Access Compliance Report

Public Rights-of-Way

Intersection ID: 8277	Main Street: GOFF_ST	Cross Street: GOSSETT_AV	Location: W
ADA ID: 05180372F750	Ramp Type: BlendTrans2	Initial Pass/Fail: Fail	Overall Compliance: No
		Severity Score: 10

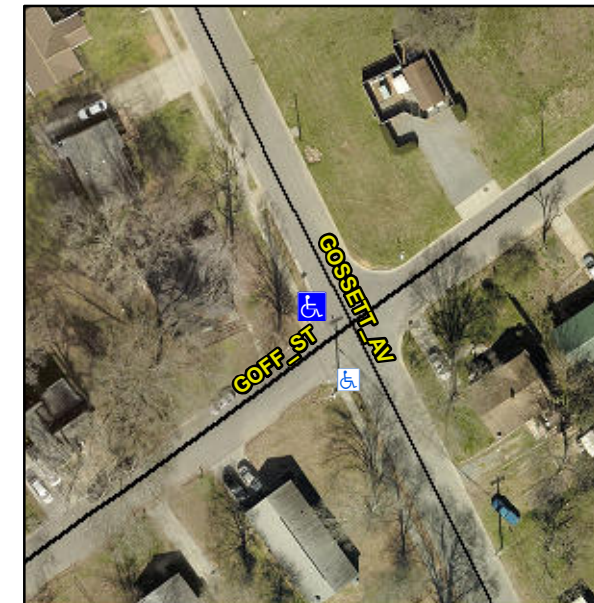
Surveyor Notes:

NO LT SW

Not Found, R304.5.1, R304.5.3

Compliance	Description	Data	Compliance	Description	Data
N/A	Ramp Length (in)	112.0	Yes	BlendTrans Slope (%)	2.1
No	Ramp Width (in)	47.5	No	BlendTrans XSlope (%)	3.5
N/A	Flare Type LT	N/A	N/A	Flare Type RT	N/A
N/A	Flare Slope LT (%)	N/A	N/A	Flare Slope RT (%)	N/A
N/A	Flare Traversable LT?	N/A	N/A	Flare Traversable RT?	N/A
N/A	Landing Length (in)	N/A	N/A	DWS Provided?	N/A
N/A	Landing Width (in)	N/A	N/A	DWS Contrast?	N/A
N/A	Landing Slope (%)	N/A	N/A	DWS Length (in)	N/A
N/A	Landing X Slope (%)	N/A	N/A	DWS Full Width?	N/A
N/A	Landing Curb? (Y/N)	N/A	N/A	DWS Offset (in)	N/A
N/A	Shared Landing?	N/A			
N/A	Gutter Ponding?	N/A	N/A	Gutter Slope (%)	N/A
N/A	Gutter Lip Ht (in)	N/A	N/A	Gutter X Slope (%)	N/A
N/A	Painted X Walk1?	No	N/A	Painted X Walk2?	N/A
	X Walk 1 Direction	To S		X Walk 2 Direction	N/A
	X Walk 1 Width (in)	N/A		X Walk 2 Width (in)	N/A
	X Walk 1 Slope (%)	0.2		X Walk 2 Slope (%)	N/A
	X Walk 1 X Slope (%)	4.8		X Walk 2 X Slope (%)	N/A

Remove & Replace Curb Ramp With Two New Directional Ramps or Equivalent.
